QUALITY ASSURANCE -- NON-CONFORMANCE REPORT

Location: Changxing Island, Shanghai, P.R. China **Report No:** NCR-000667
Prime Contractor: American Bridge/Fluor Enterprises, a JV **Date:** 30-Jan-2010
Submitting Contractor: Zhenhua Port Machinery Company, Ltd (ZPMC), Changxing Island **NCR #:** ZPMC-0637

Reference Description: The radius and transition of the X7 FB vertical stiffener plates are not fabricated per the approved shop drawings

RFI No.: ABF-RFI-002075R00 Submitted By: Jiao, Gang Pages: 3
 RFI Date: 05-March-2010 Contact Name: Jiao, Gang Pages Attached: 2
 Phone No. 86-134-8265-6572

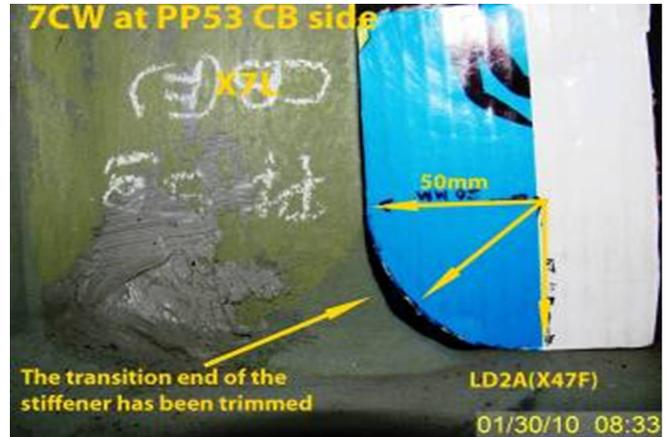
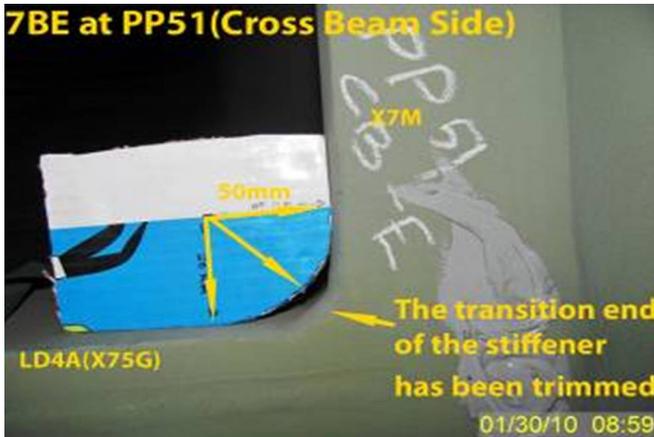
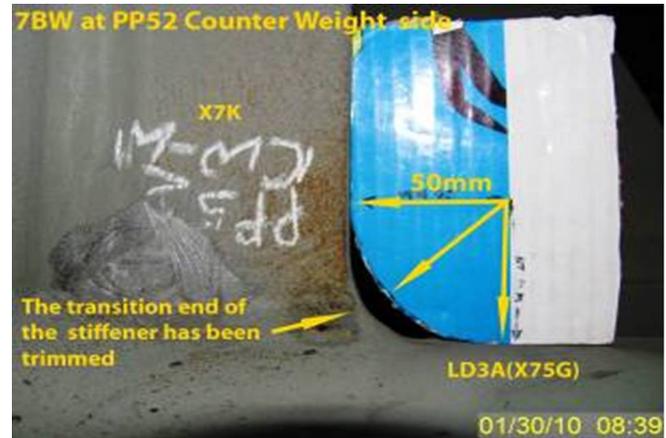
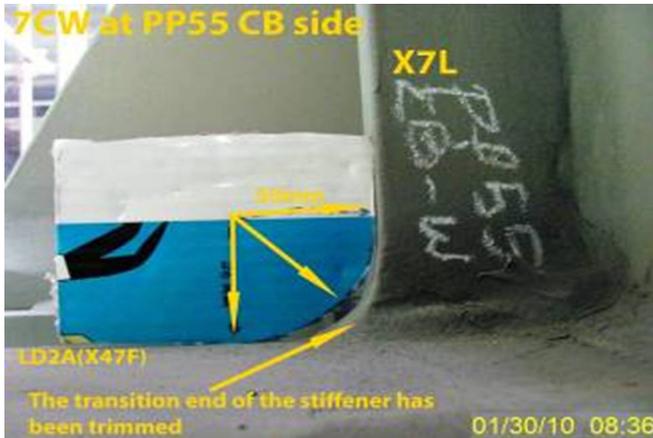
During the Quality Assurance (QA) random in-process visual inspection of the OBG segments 7BW and 7CW in the Trial Assembly area, this QA inspector discovered the following issues:

- The R=50mm portion at the transition end of the X7 floorbeam vertical flange (stiffener) to Longitudinal Diaphragm has been trimmed and found four locations that were not in compliance with the approved shop drawings (OBG Standards- Floor beam Details-X7).
- The 1st Weld joint is identified as SEG035C-032 at PP51 Crossbeam Side.
- The 2nd Weld joint is identified as SEG035B-040 at PP52 Counter weight Side.
- The 3rd Weld joint is identified as SEG037C-023 at PP53 Crossbeam Side.
- The 4th Weld joint is identified as SEG035C-008 at PP55 Crossbeam Side.
- All joints are Partial Joint Penetration (PJP) as per WD20W, weld joint connecting the vertical floorbeam flange (stiffener) X7 to the Longitudinal Diaphragm top flange plate.

AWS D1.5 2002 Section 3.2.5: Reentrant corners of base-metal cut edges shall be formed to provide a smooth transition with a radius of not less than 25 mm [1 in.] that meets the adjacent edges without offset or cutting past the point of tangency. The reentrant corners may be formed by thermal cutting, followed by grinding to meet the surface requirements of 3.2.2.

Propose a resolution for the identified non-conformance with revised procedures to prevent future occurrences and provide documentation to show that the radius and transition on the FB stiffeners have been repaired according to the approved show drawings. A response for the resolution of this issue is expected within 14 days.

Provide the radius shown on the shop drawings.

Date: 2010-03-11
File Name: SK-2075R0-1

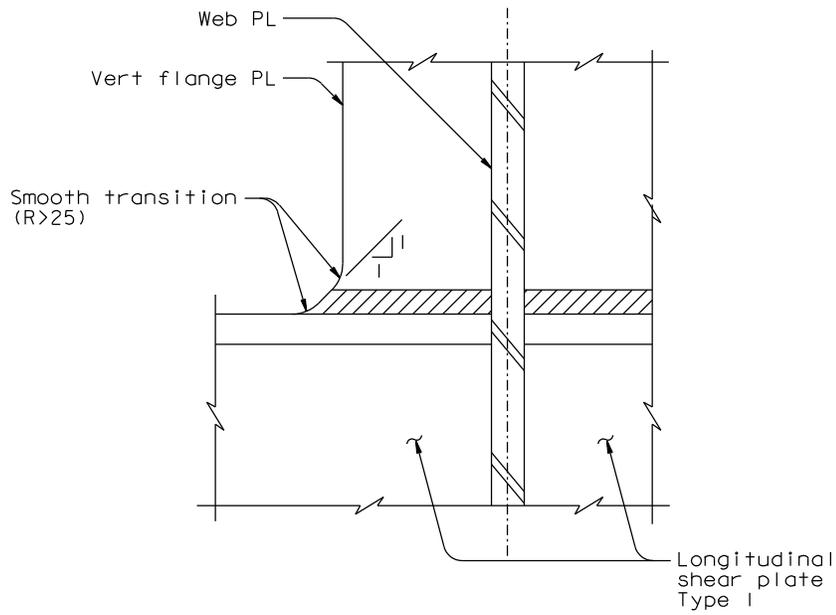
The reentrant corner (flare) in the approved drawings specify a 50mm radius for the connection between vertical floorbeam flange (stiffener) X7J and Longitudinal Diaphragm flange plate X42A. It has been noted that at some locations the as-built reentrant corner is less than 50mm in radius. Per AWS D1.5 Section 3.2.4, ABFJV considers the minimum acceptable radius for a reentrant corner as 25mm provided there is a smooth transition that meets the adjacent edges. Please confirm this understanding is correct.

Where the base metal of the vertical flange PL has not been altered (cut, grind, burn, etc) after initial welding was preformed and the welding passed the NDT testing, no action is needed.

Where the base metal of the flange PL has been altered by any mechanical means (cut, grind, burn, etc.), the reentrant corner shall be transitioned at a 1:1 slope for the height of the PJP 11(8). A smooth transition of radius 25 mm or greater shall be provided at the start and finish of the 1:1 transition.

See attached sketch SK 2075R0-1.
